Terex Utilities**PRODUCT ADVISORY****PA688****DATE:** 3/1/2021**REVISED:****TO:** Owners, Users, Dealers, and Installers**MODELS AFFECTED:** Terex Aerial Devices & Digger Derricks on Freightliner Chassis**SUBJECT:** Freightliner Chassis with Tri-Axle Rear Air Suspension**Issue:**

**Subject: Hendrickson Primaax EX 69,000 lb
Tri-Axle Rear Air Suspension Height-Control
Valve Relocation**

The attached document provides work instructions for relocating the height-control valve downward 1.62 inches (41.3 mm) to prevent the linkage from protruding above the top flange of the frame when the suspension air is dumped.

Figure 2. Top end of ride height control linkage

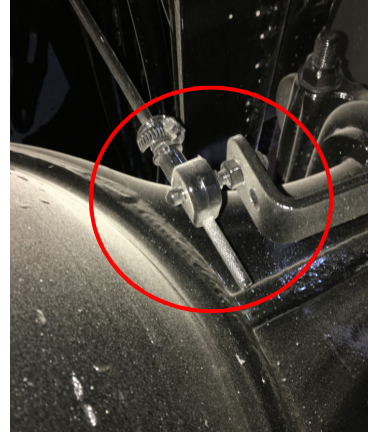
Inspect the ride control linkage, including the attachment points as shown in Figures 1, 2 & 3, for signs of damage such as bending and/or cracking or indications of contact with the bottom of the subframe. Complete this inspection at the next scheduled inspection interval or at the next scheduled servicing of the chassis. If the linkage has failed, limit road travel to reduce the amount of shock loading into the aerial device or digger derrick until repaired.

If the ride control linkage contacts the bottom of the subframe or shows any damage, contact your nearest Freightliner dealership to determine the required repairs and reference Freightliner Customer Advisory Letter CAL FTL 32-006. If you are unable to locate your dealership, go to the Freightliner website, freightliner.com, and click the DEALERS button in the upper right-hand corner to search for the local dealership.

Fig. 1, Location of Height-Control Valves

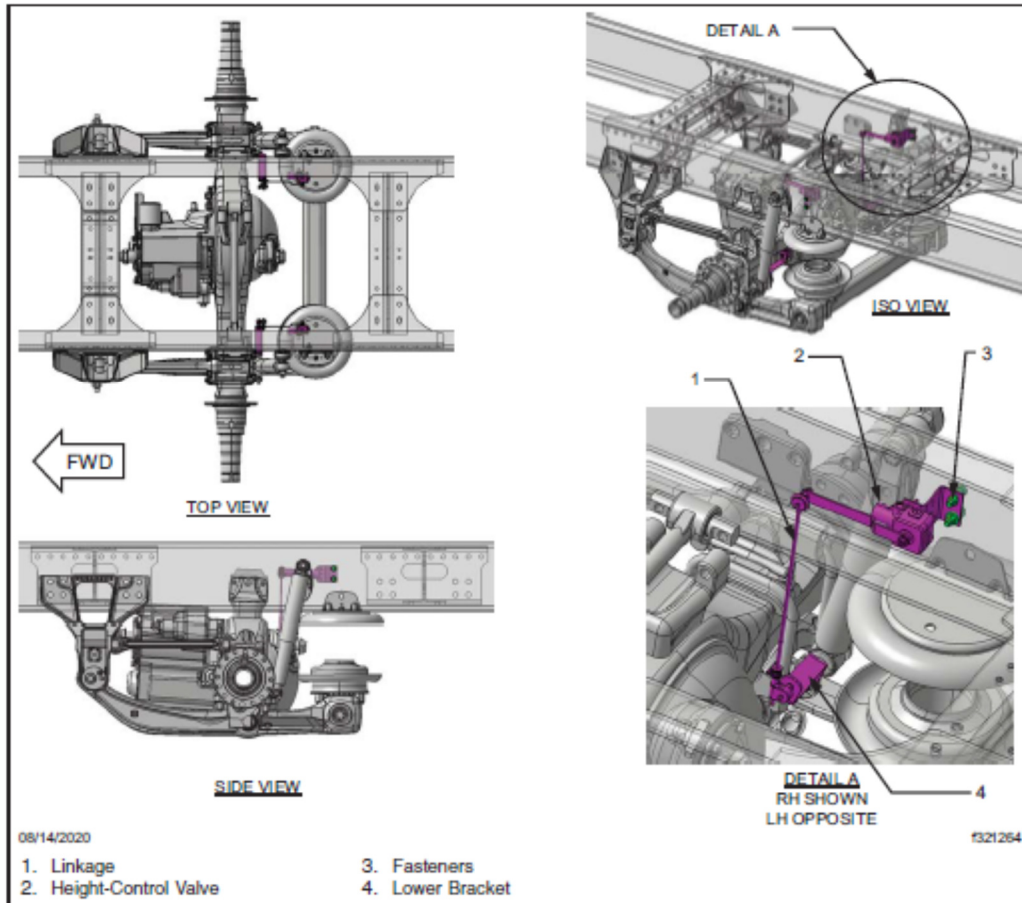
1. Park the vehicle on a level surface, set the parking brakes, and *chock the tires*.
2. Put the transmission in neutral and build the air pressure to at least 100 psi. Shut down the engine.
3. Release the parking brakes.
4. Locate the height-control valves installed just rear of the mid-axle inside the left-hand and right-hand frame. See [Fig. 1](#).

Fig. 2, Measuring For the New Frame Rail Holes

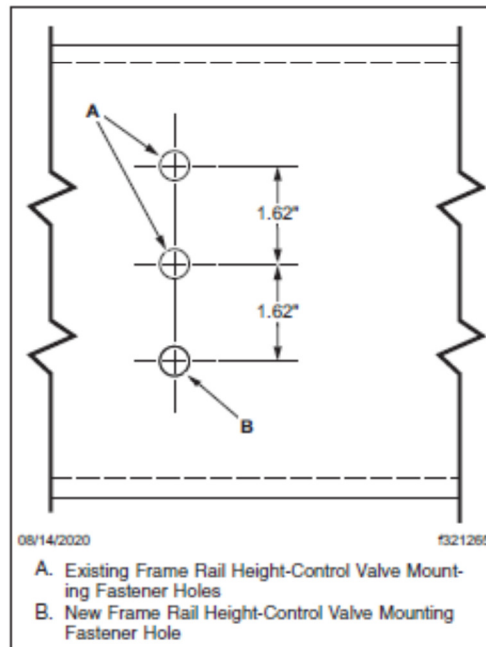
5. Disconnect the linkage from the lower bracket on both sides of the vehicle.
6. Pin both height-control valve levers in the neutral position with a 5/32-inch drill bit.
7. Remove the height-control valve mounting fasteners from the frame and move the valves and linkages away from the frame.
8. Mark both the left-hand and right-hand frame rail 1.62 inches (41.3 mm) below the lower existing height-control valve drilling on each rail. See [Fig. 2](#).

9. Drill a 1/4" diameter pilot hole at both the left-hand and right-hand frame rail marks.
10. Finish the mounting holes with a 7/16" diameter drill bit at low speed.
11. Install the height-control valves on the lower two holes using the existing 3/8" fasteners.
12. Install the linkage to the lower bracket by adjusting the rod in the lower rubber adjustment sleeve.
13. Remove the drill bit pins from the height-control valve levers.
14. Check the suspension ride height by measuring between the shock mounting bolts. Measure from the centerline of the upper shock bolt to centerline of the lower shock bolt. The distance should equal 20.07 inches (50.98 cm). If necessary, set the suspension height by adjusting the rod in the lower rubber adjustment sleeve to achieve 20.07 inches (50.98 cm). See [Fig. 3](#).
